Date:	June 1, 2026
State Project #:	089-0172
Project Name:	Smith Elementary School
Project Location:	142 Rutherford St., New Britain CT 06051

CLARIFICATIONS

New Britain, CT
KBA #24006.01 | SPN#089-0172

FIGURE 15
Temporary Pedestal Service - Site Built
(Manufactured Meter Pedestals May Be Used - Refer To Approval List)

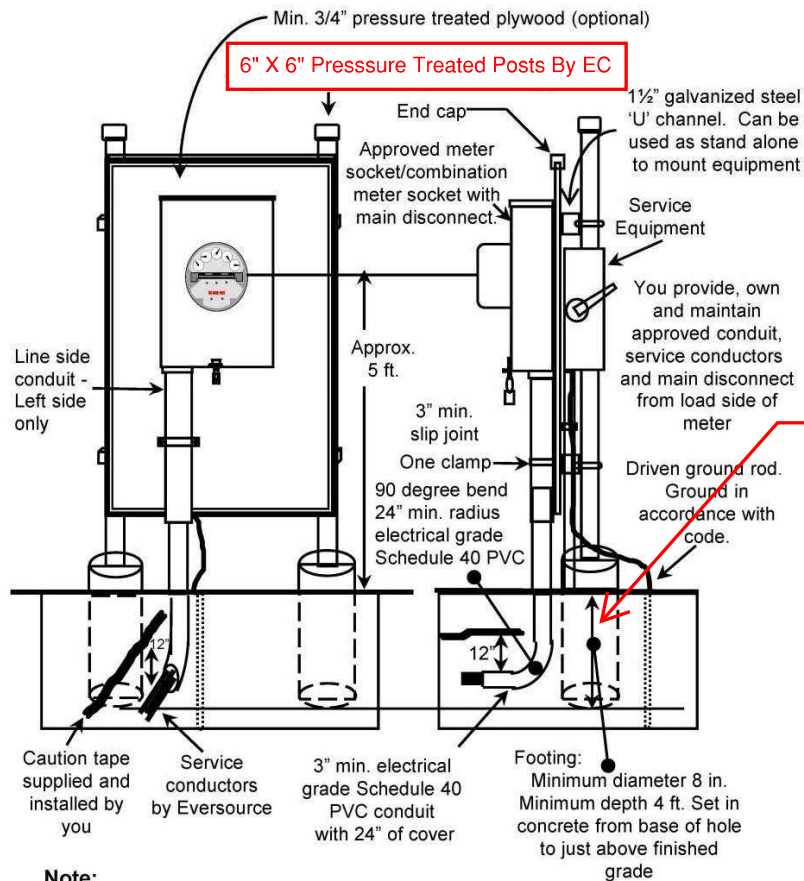
ADD Note 01.81 Reference the Temporary Pedestal Service Detail provided in Bull 1.01. Include excavation to 3' below grade, 12" sonotube, concrete and backfill for the two pedestal posts at the temporary electrical services. Posts and backboards are by others. Coordinate all work with the Electrical Contractor.

- The temp service will be mounted on a temp pedestal in accordance with Eversource standards. Reference Eversource Pedestal Detail in Bull 1.01. The posts shall be 6" X 6" X 10' pressure treated wood (buried 3') in lieu of steel. Also, the use of rigid conduit is not required. Excavation, sonotube, concrete and backfill are by the Site Contractor. Wood posts and plywood backboards are by the Electrical Contractor.

CONSTRUCTION
LOGISTICS
PLAN

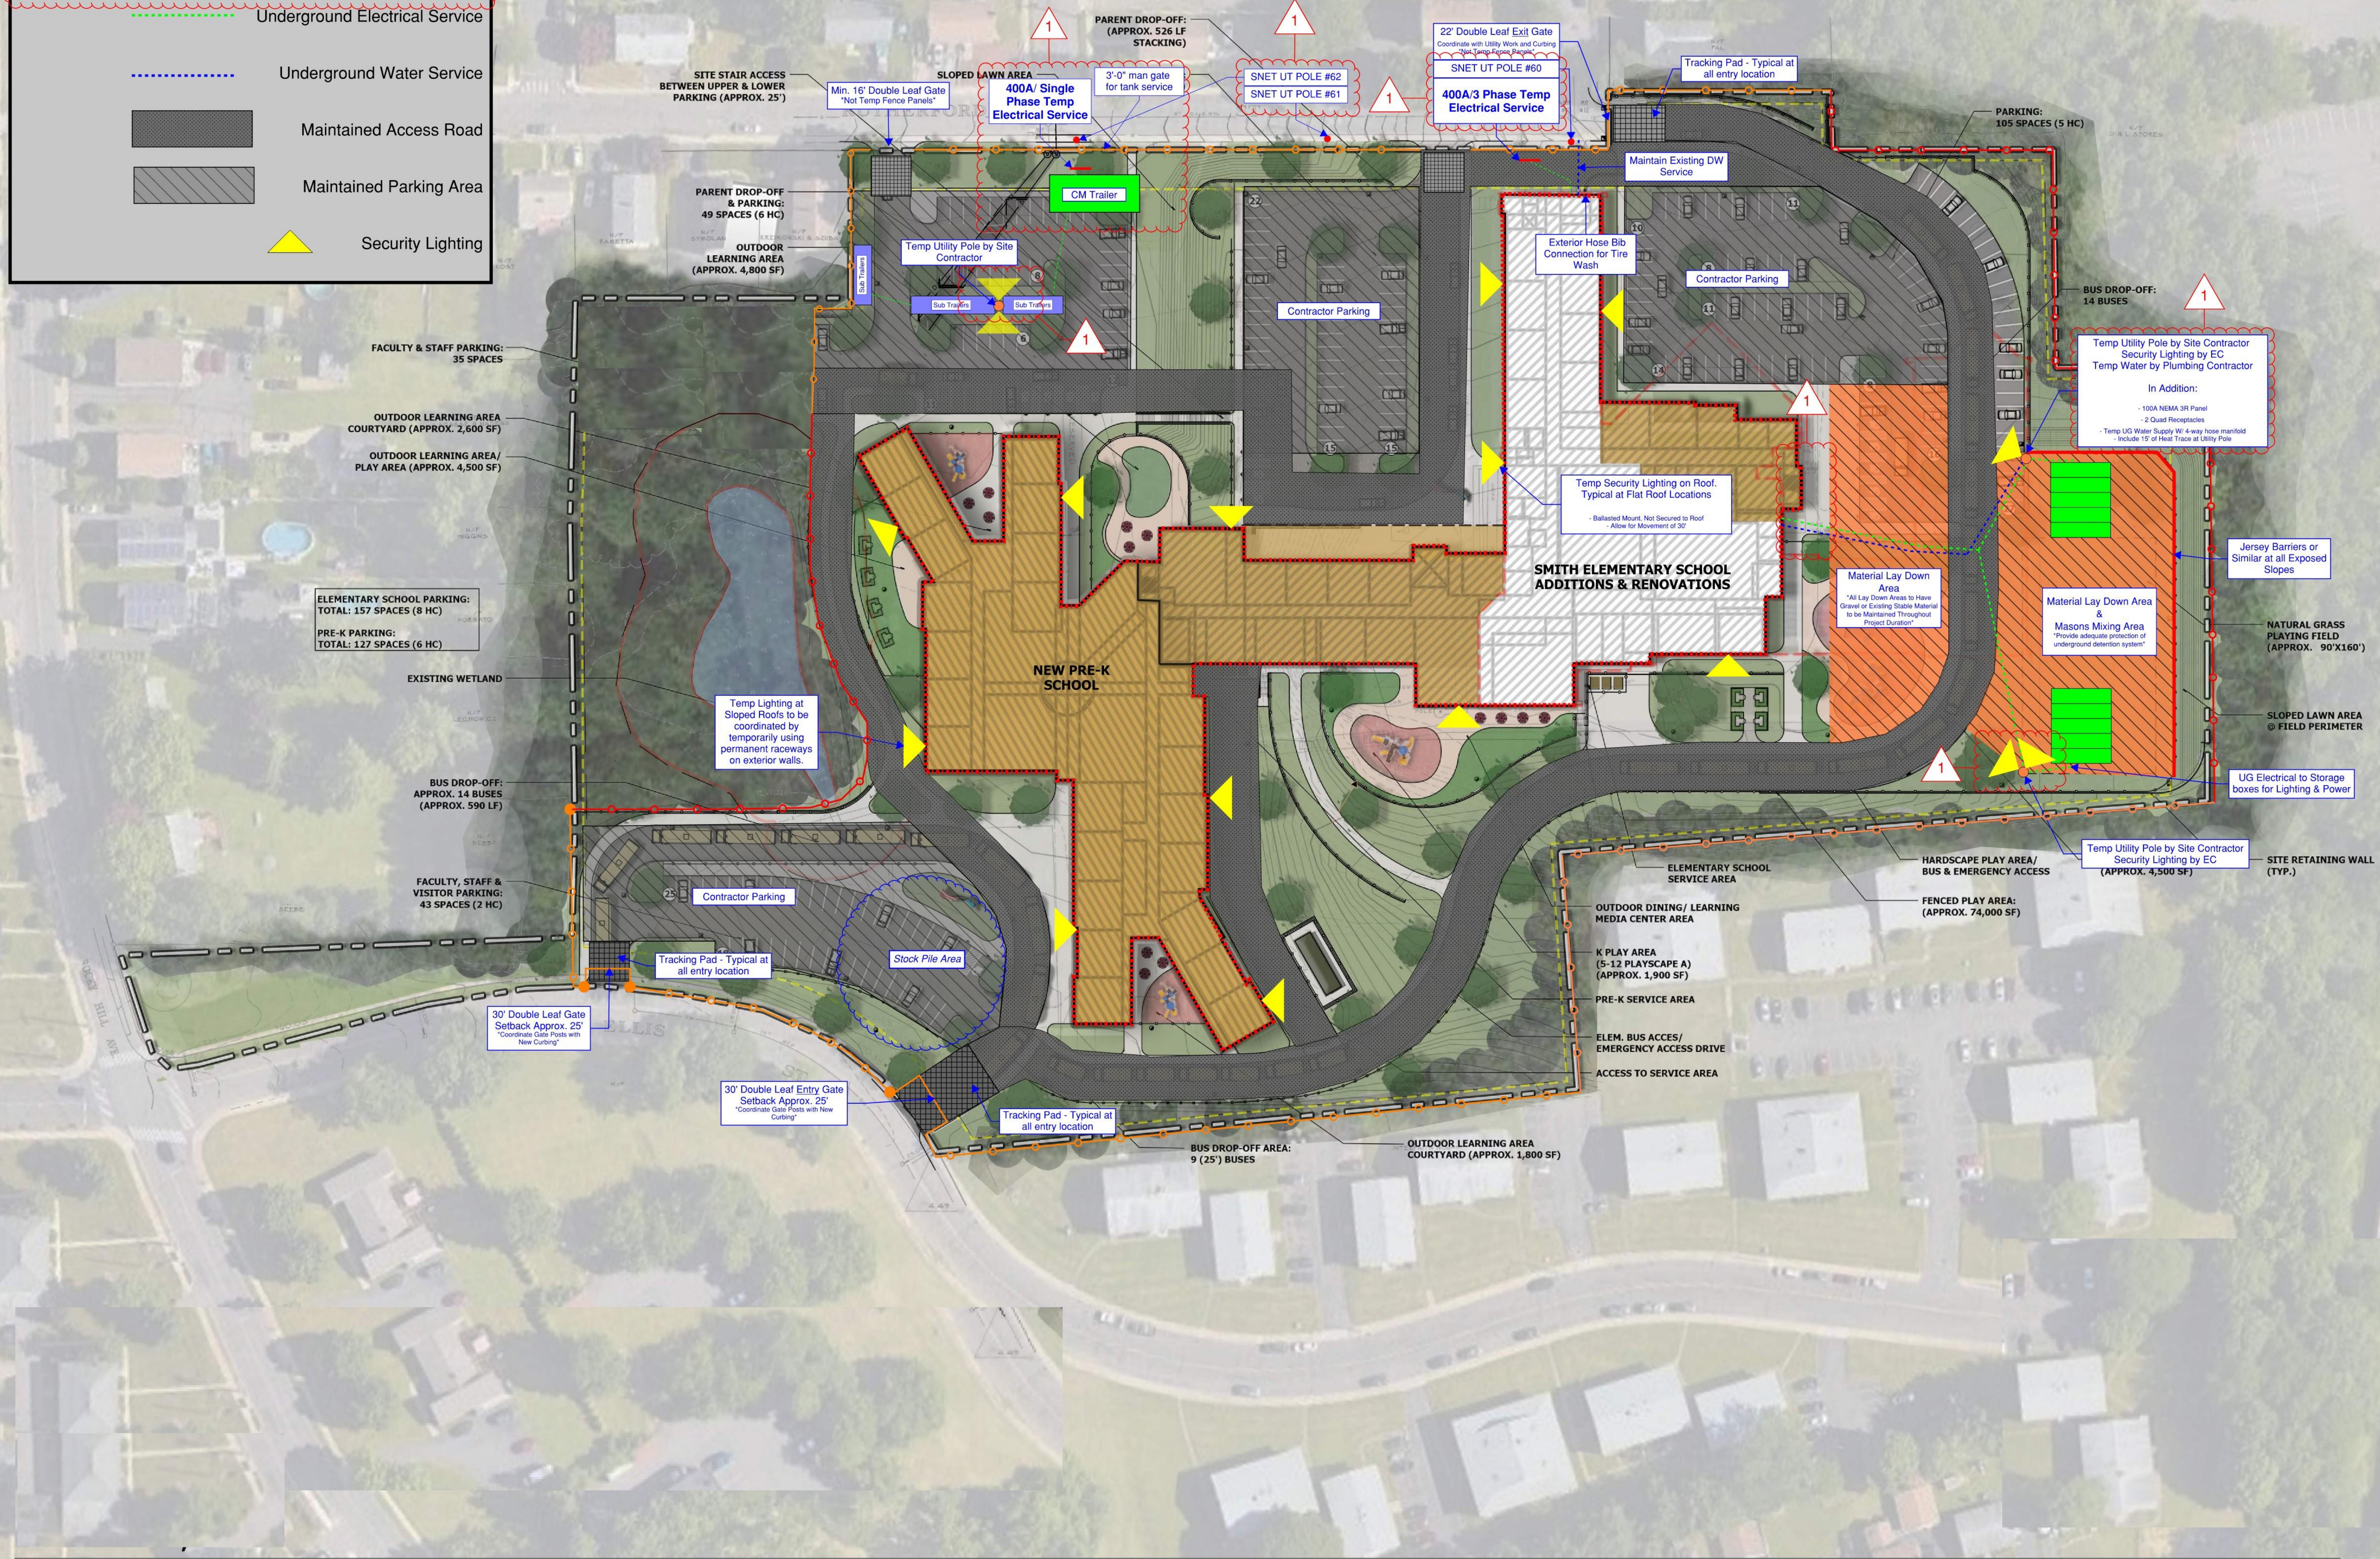
ADD Note 01.58 Temp Electrical Services: The Electrical Trade Contractor is responsible for furnishing and installing two temporary electrical services. Reference Drawing CLP 1.00 Construction Logistics Plan for locations. Utility company fees are to be paid from the Utility Fees Allowance. Energy usage charges will be paid by others. All excavation and backfill are by others. Include coordination with utility providers and the Construction Manager. Maintain all items for the duration of the Project. All equipment is for use and consumption. Pedestal, mounts and supports to be in accordance with Eversource standards and code compliant. All equipment shall be NEMA 3R rated. Include temporary 120V feeds in conduit to site lighting and outlets.

- Install temp exterior panels and outlets as shown on the Site Logistics Plan CLP 1.00.

TITLE: **PARTIAL REVISED NORTH ELEVATION
CLARIFICATION**

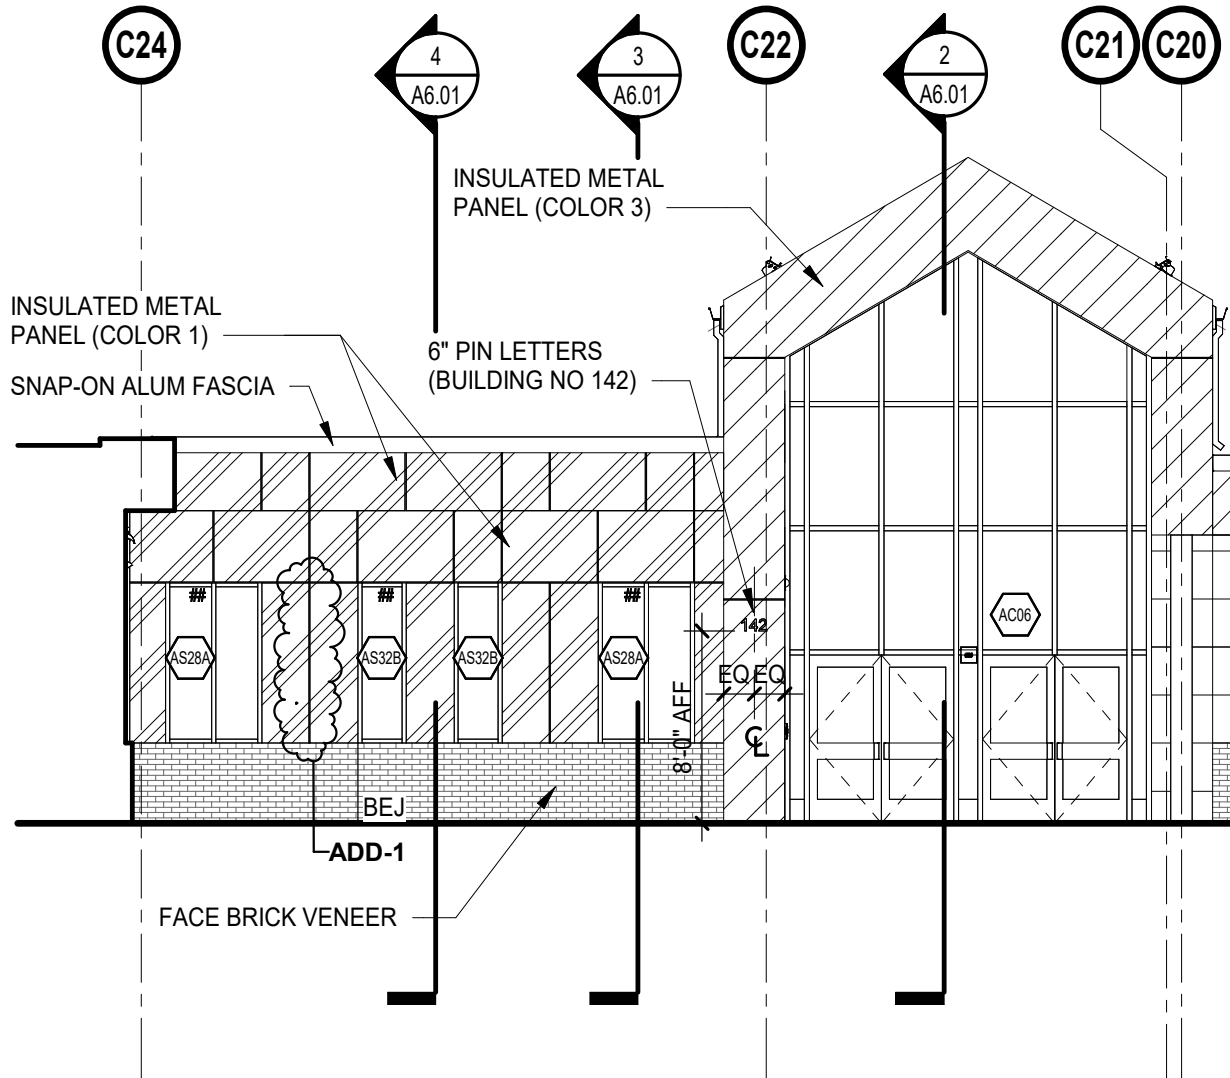
c. Tile Size: ~~47.5" W X 63" H~~. **15.67"W x 15.67"H Provide 3 tiles wide x 4 tiles high total.**

TITLE: REVISED A10 SERIES NOTES

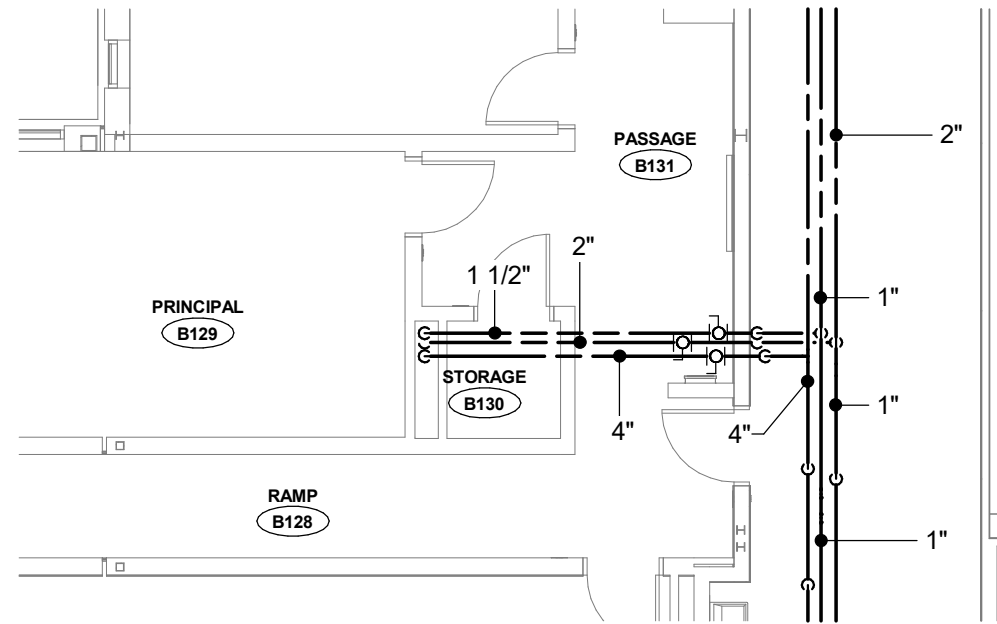
PROVIDE STANDARD AND/OR CUSTOM INSERTS AT ALL ELECTRICAL, FIRE PROTECTION, SIGNAGE CUT-OUTS AT GYM WALL PADS. SIZES PER FIELD DEVICE DIMENSIONS.
